ADDENDUM 03, DELTA 03 DATE 05.01.2026

PROJECT: Santa Rosa Freestanding Emergency Room

ARCHITECT'S PROJECT NUMBER:
225014.00

OWNER: HCA Florida Fort Walton-Destin Hospital

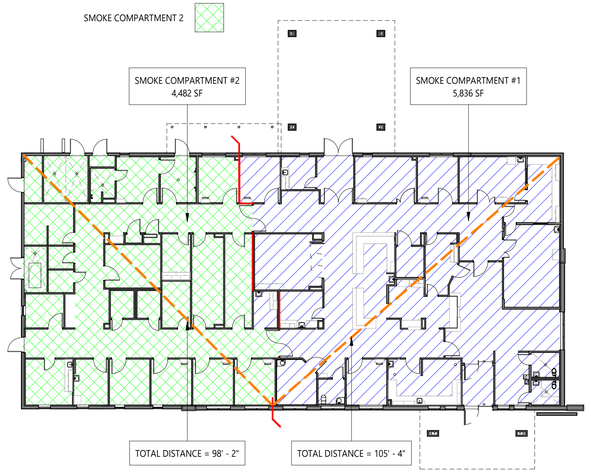
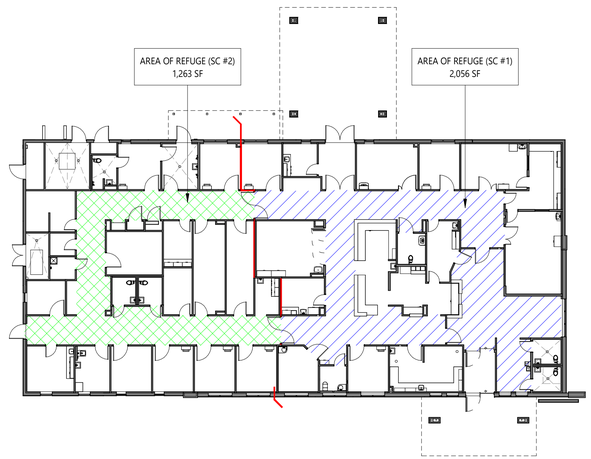
1. Reference "Occupant Load:"
    a. Revised the occupant load factor for the Waiting Area Room 101; subsequent occupant load totals revised to match.
2. Reference "Area of Refuge Calculation:"
    a. Revised the area of refuge calculations to match the updated occupant load table.

1 FLOOR PLAN - LIFE SAFETY
SCALE: 1/8" = 1'-0"

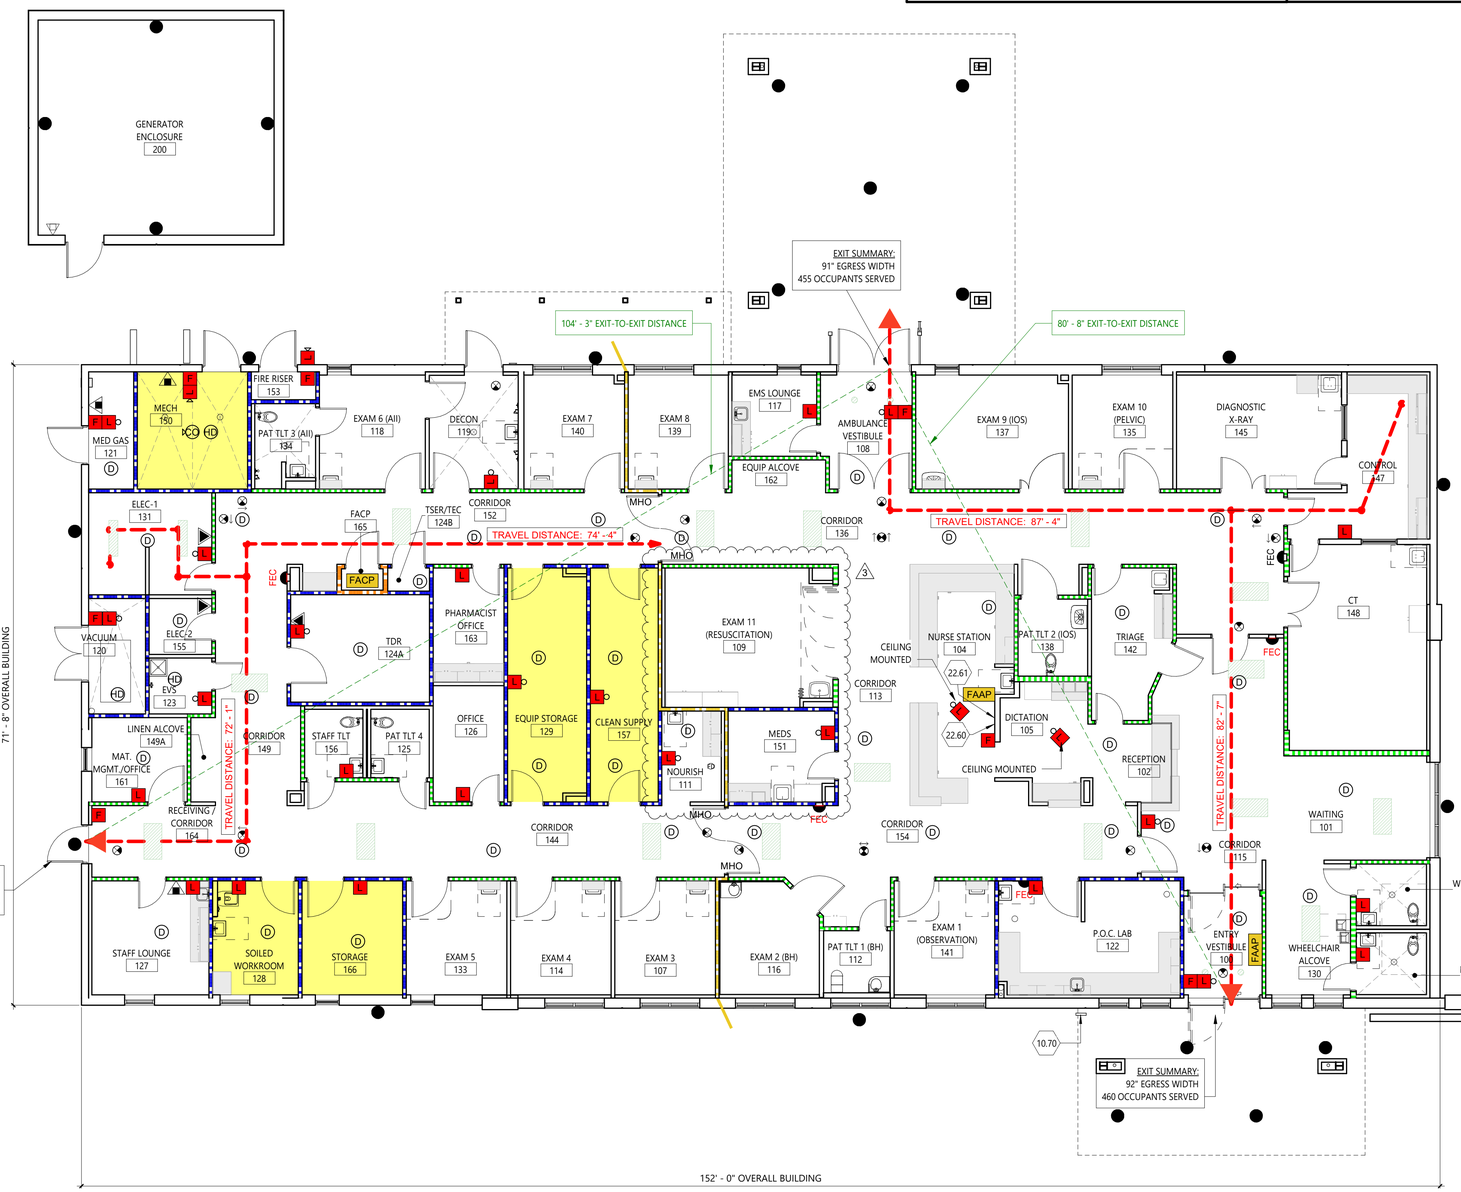
1. Reference "Life Safety Plan Notes:"
    a. Revised the partition identification text for the smoke barrier for additional clarification and per comments received from the Joint Commission on similar projects.
2. Reference "Life Safety Legend:"
    a. Revised the exterior fire extinguisher description per inspection comments received from received from the Joint Commission on similar projects.
3. Reference Detail 1: "Floor Plan – Life Safety:"
    a. Revised the Trauma Room, Meds Room and Nourishment Alcove core per client direction.

1 FOUNDATION PLAN
SCALE: 1/8" = 1'-0"

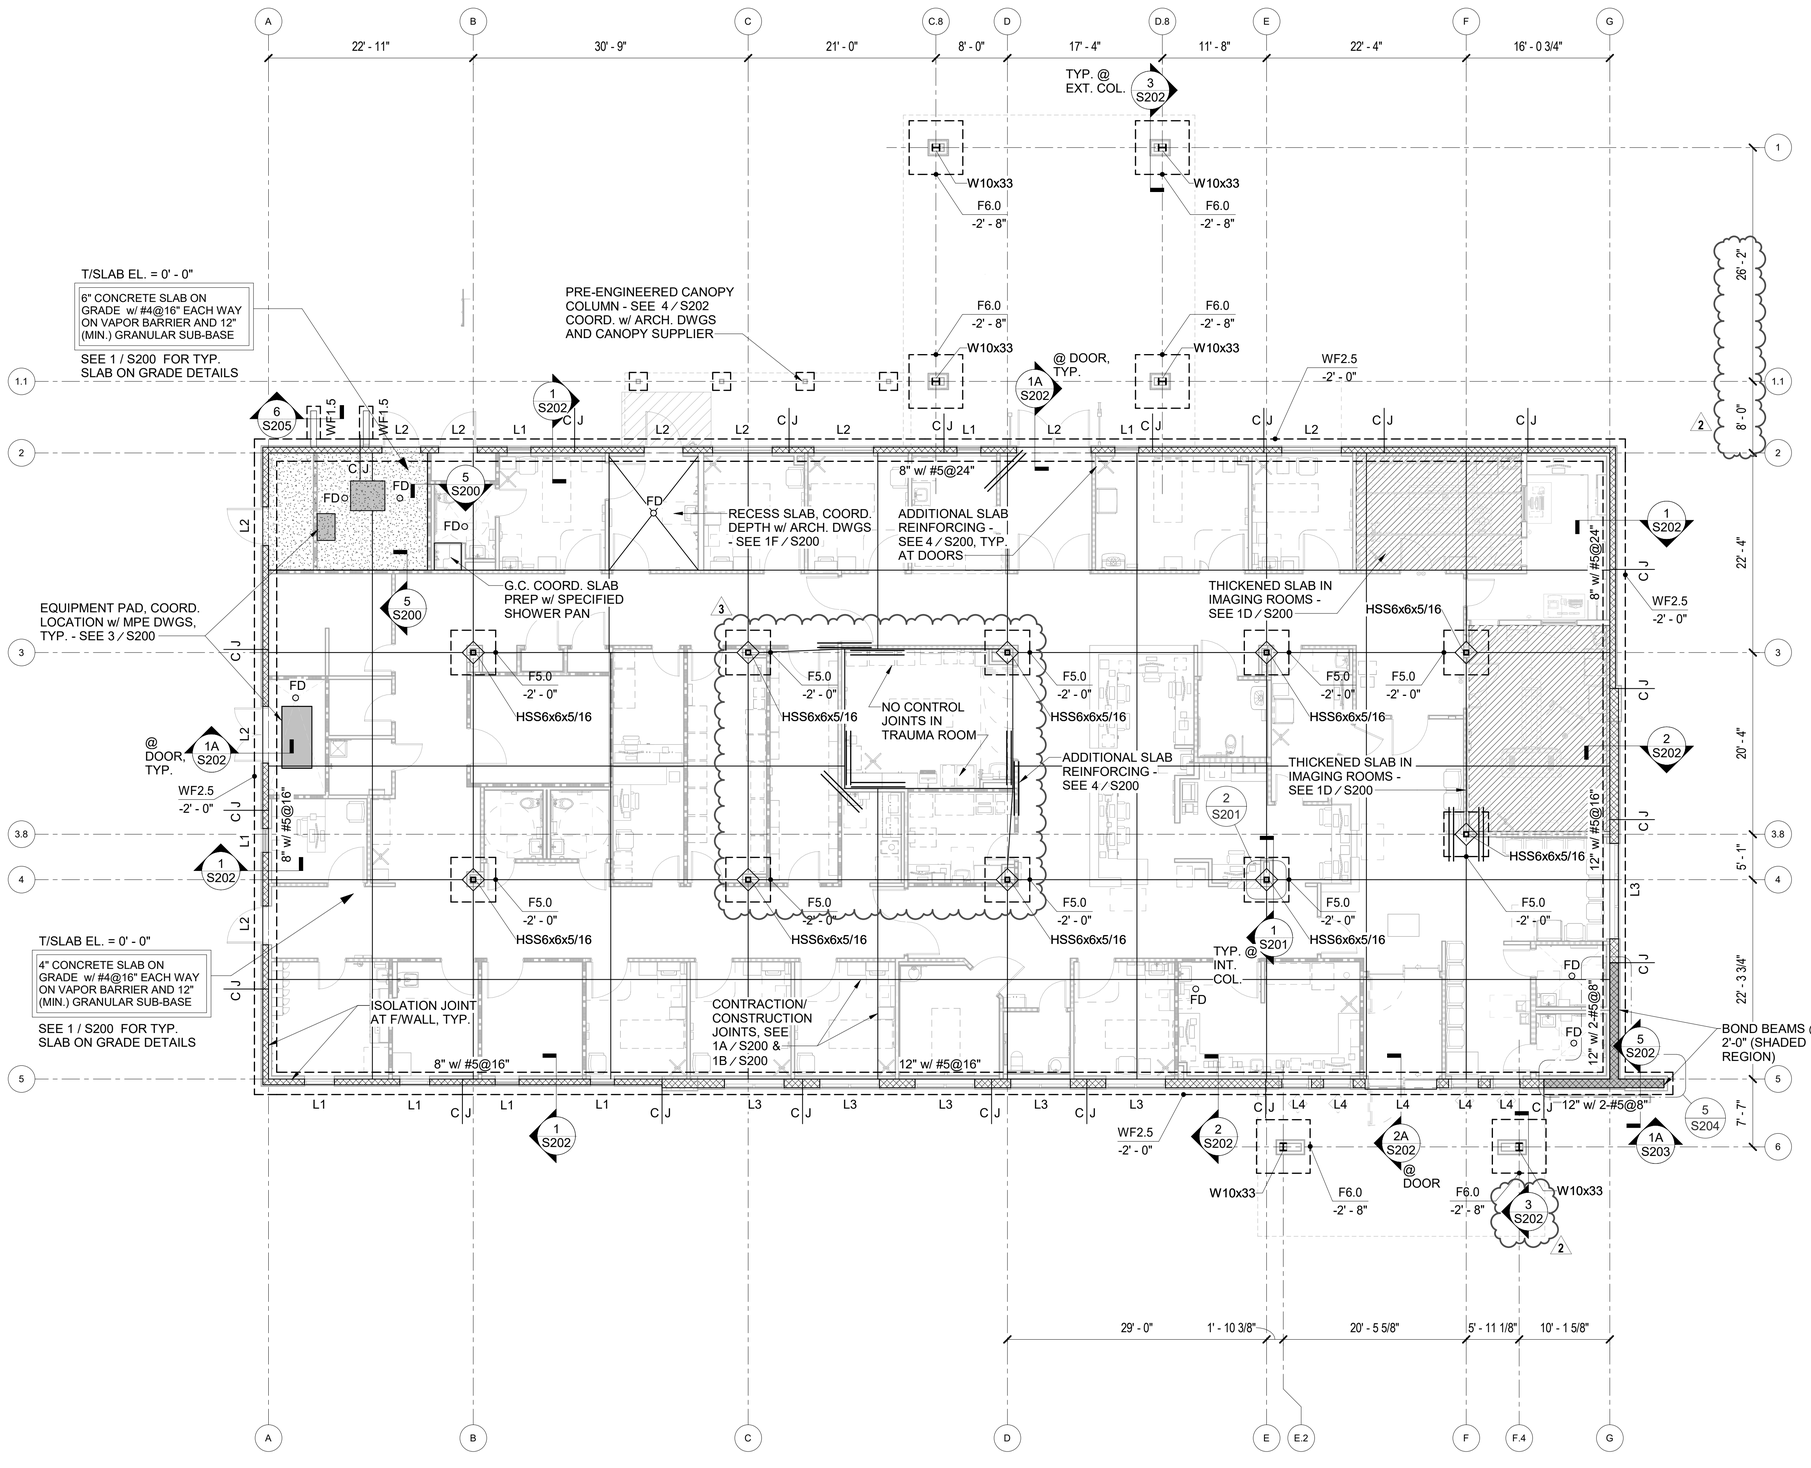
1. Adjusted slab construction/contraction joints around revised trauma room location per owner/architect coordination.

1 FLOOR PLAN - NOTED
SCALE: 1/8" = 1'-0"

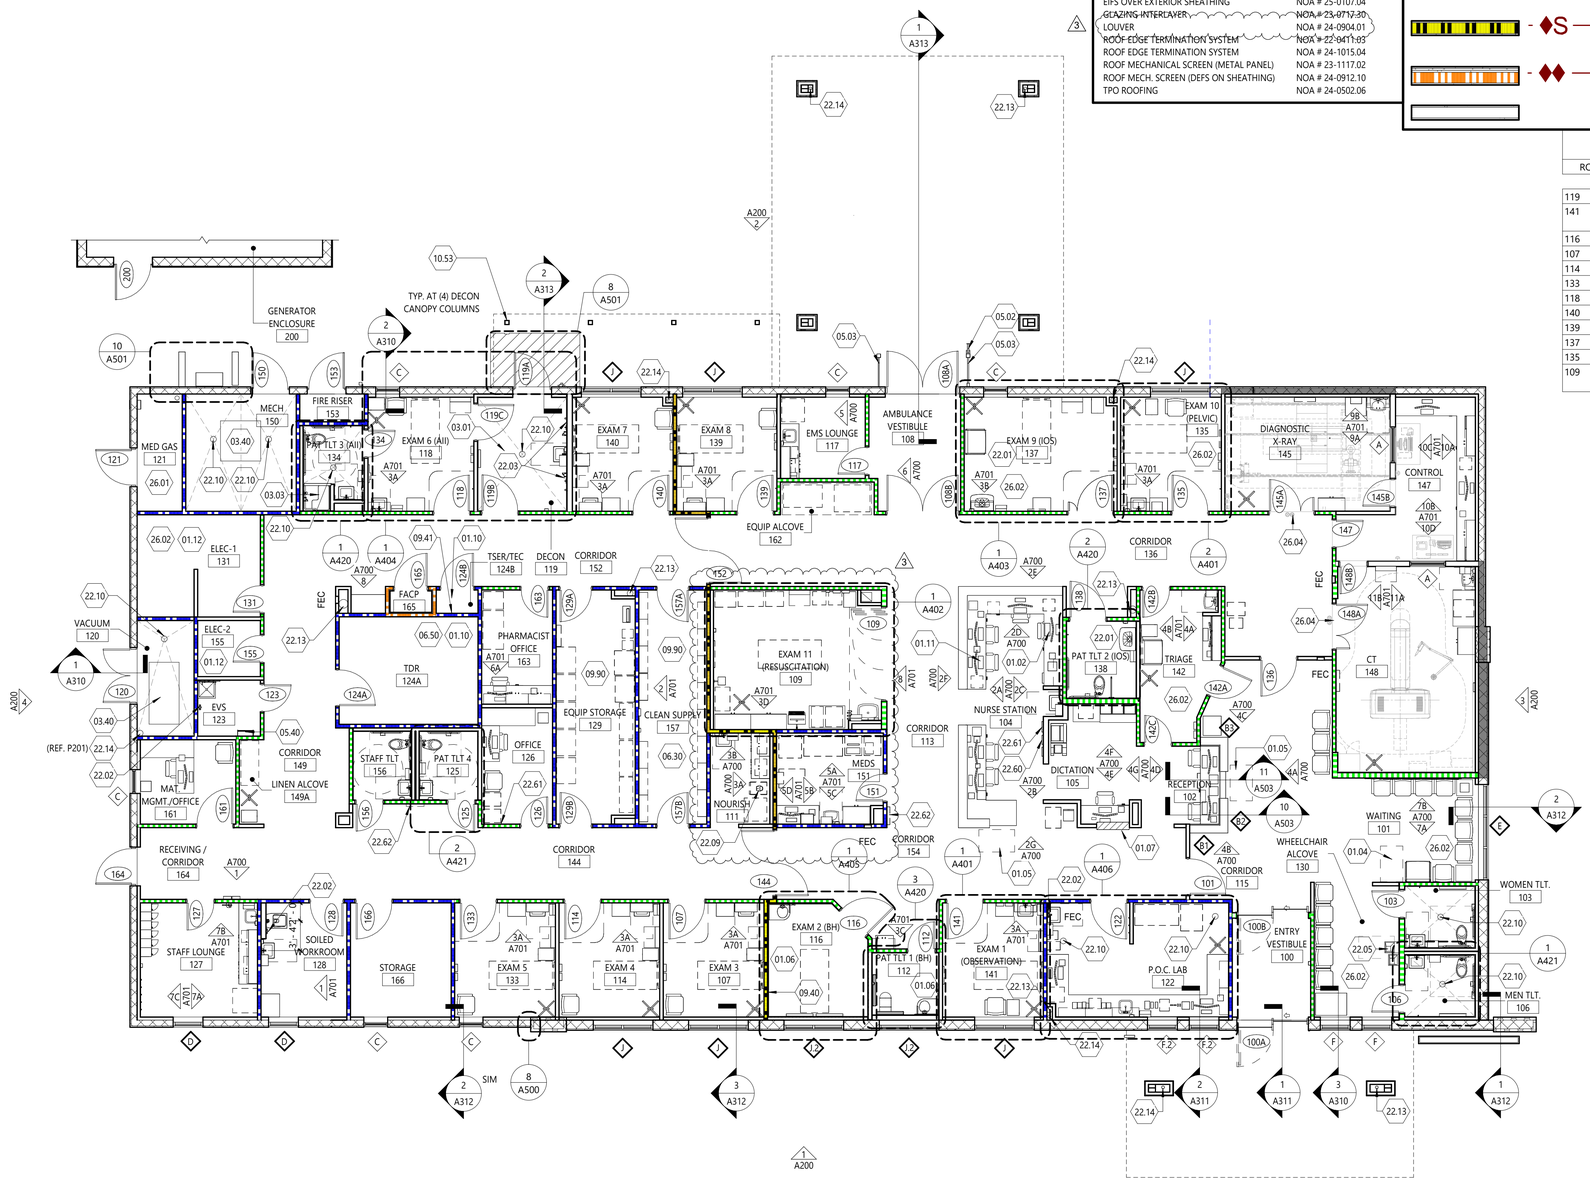
1. Reference "NOA Listings:"
    a. Revised the NOA reference for the exterior louver to coordinate with the products specified by the mechanical engineer.
2. Reference Detail 1: "Floor Plan – Noted:"
    a. Revised the Trauma Room, Meds Room, and Nourishment Alcove core per client direction.

1 FLOOR PLAN - DIMENSION
SCALE: 1/8" = 1'-0"

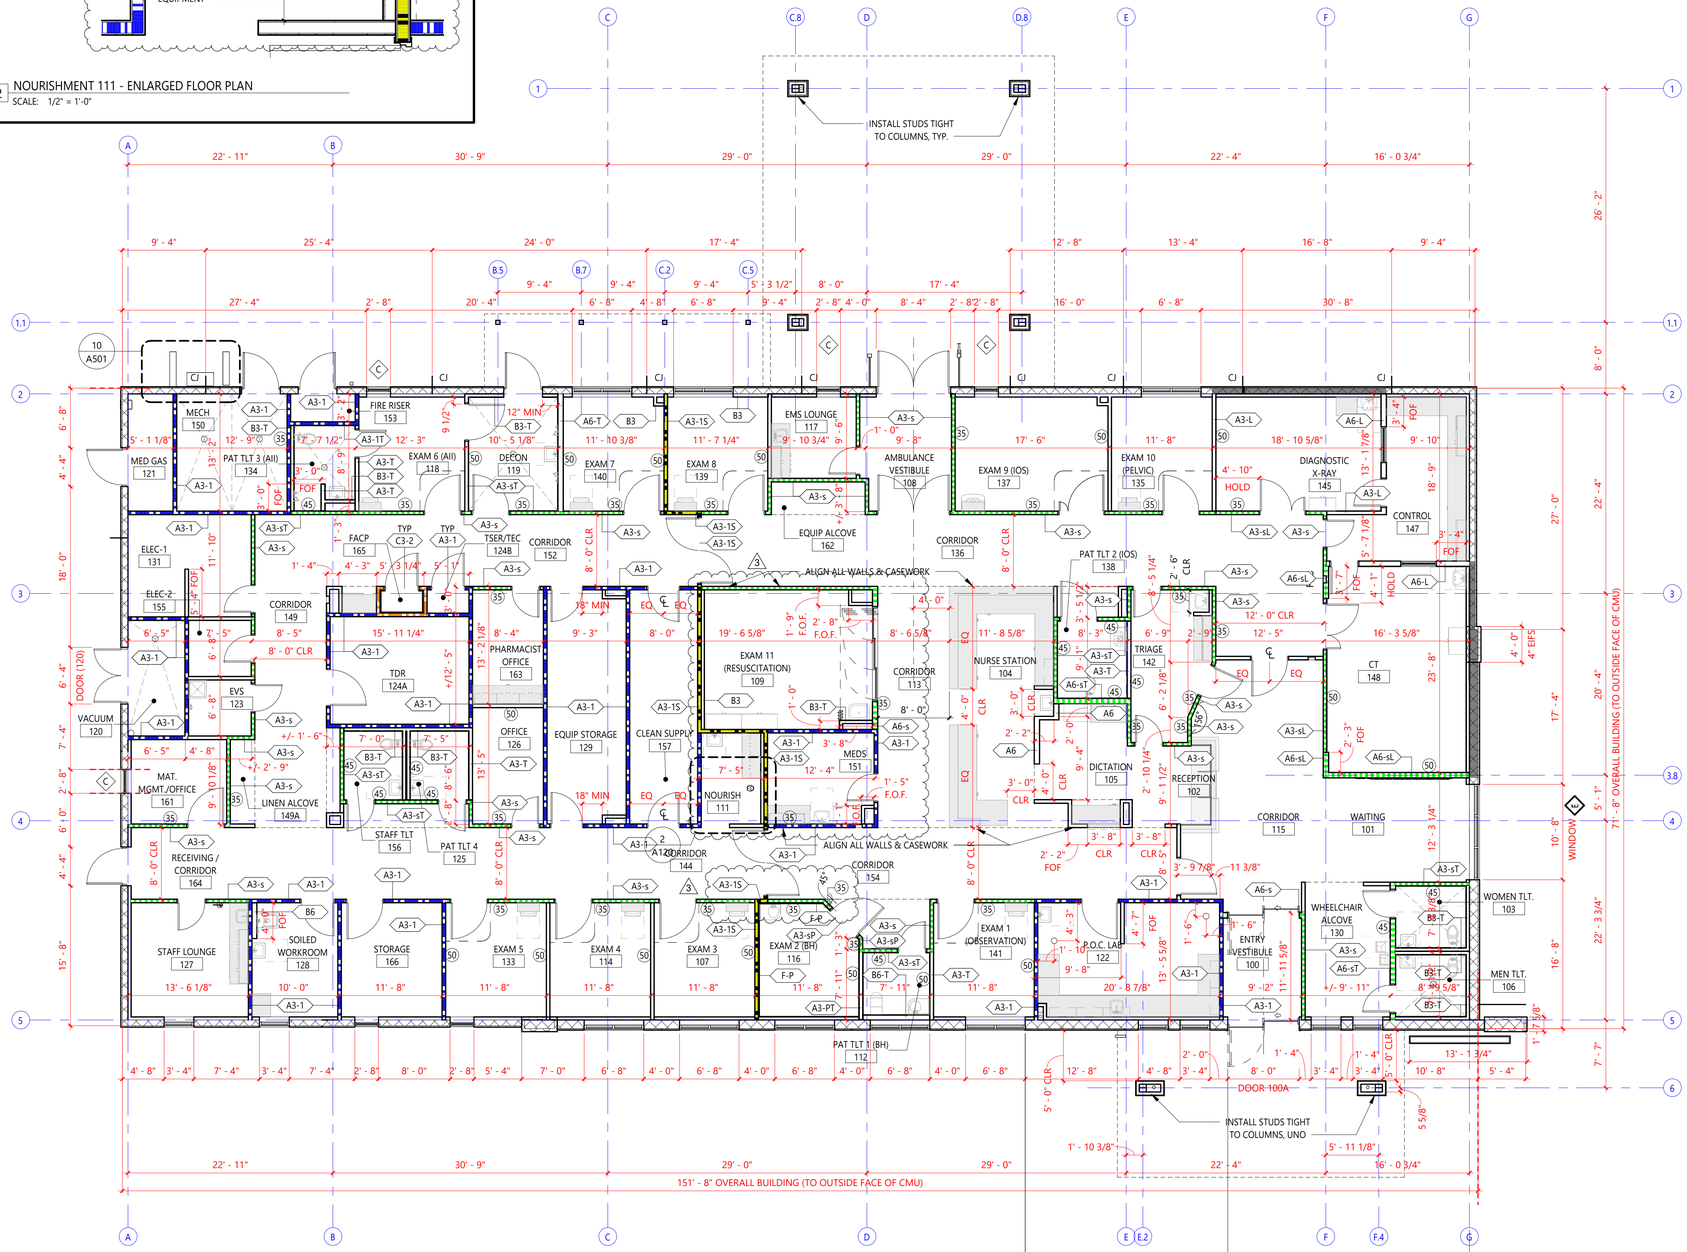
1. Reference Detail 1: "Floor Plan – Dimension:"
    a. Revised the Trauma Room, Meds Room, and Nourishment Alcove core per client direction; associated dimensions revised as necessary.
    b. Revised the rated wall intersection at Behavioral Exam and added a B-3 furred out wall in the exam room.
2. Reference Detail 2: "Nourishment 111 – Enlarged Floor Plan:"

a. Enlarged plan updated per changes to the Trauma Room, Meds Room, and Nourishment Alcove.

1 FLOOR PLAN - EQUIPMENT
SCALE: 1/8" = 1'-0"

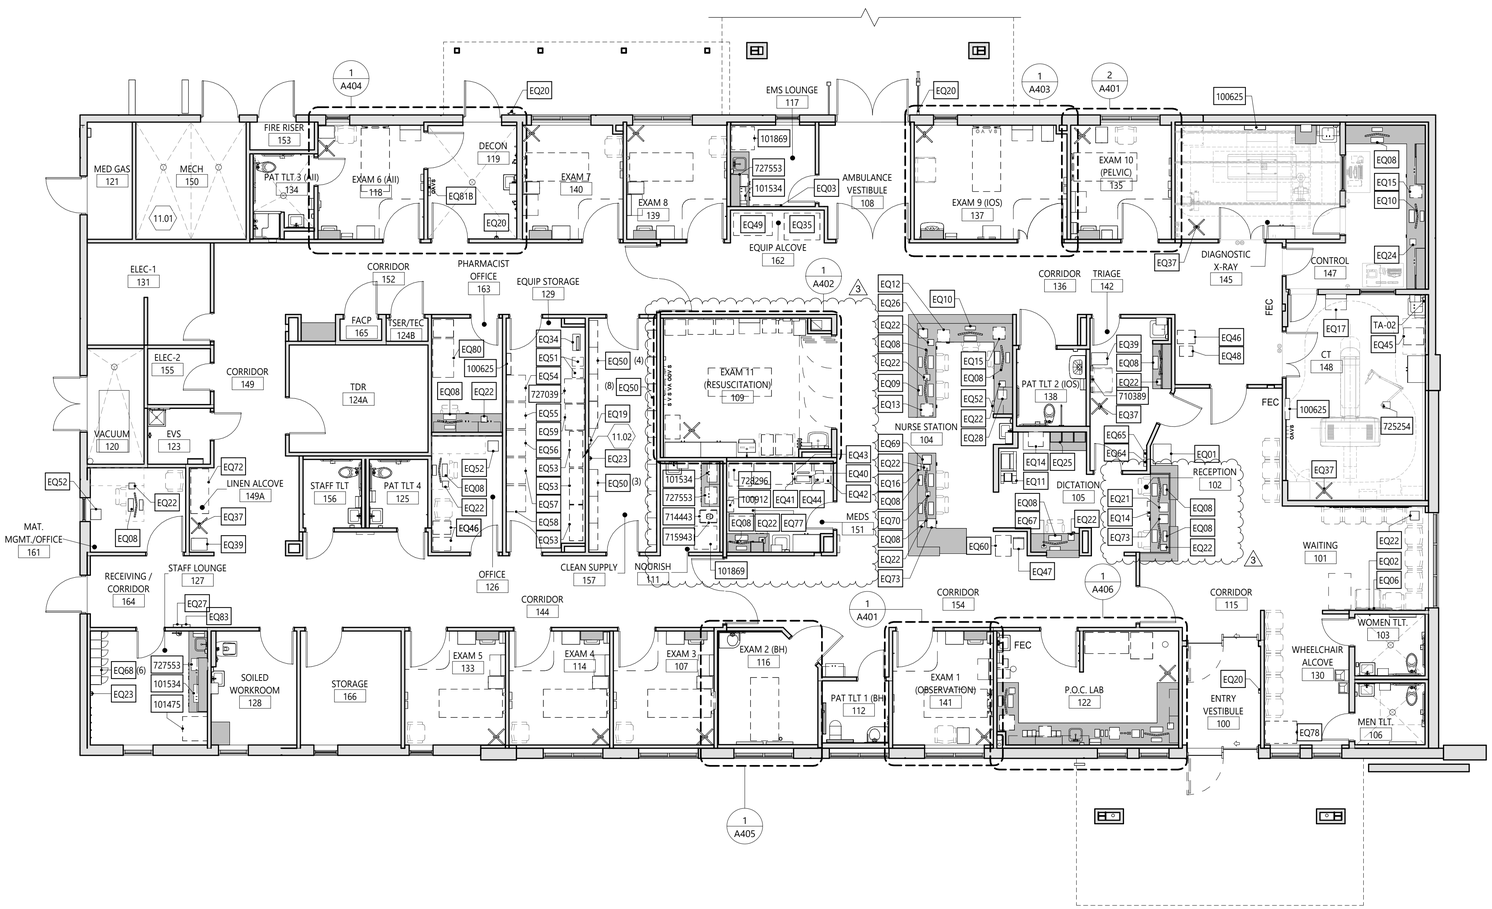
1. Reference Detail 1: "Floor Plan – Equipment:"
    a. Revised the Trauma Room, Meds Room, and Nourishment Alcove per client direction; associated equipment and equipment tags revised as necessary.
    b. Equipment tags added at Reception for additional clarification.
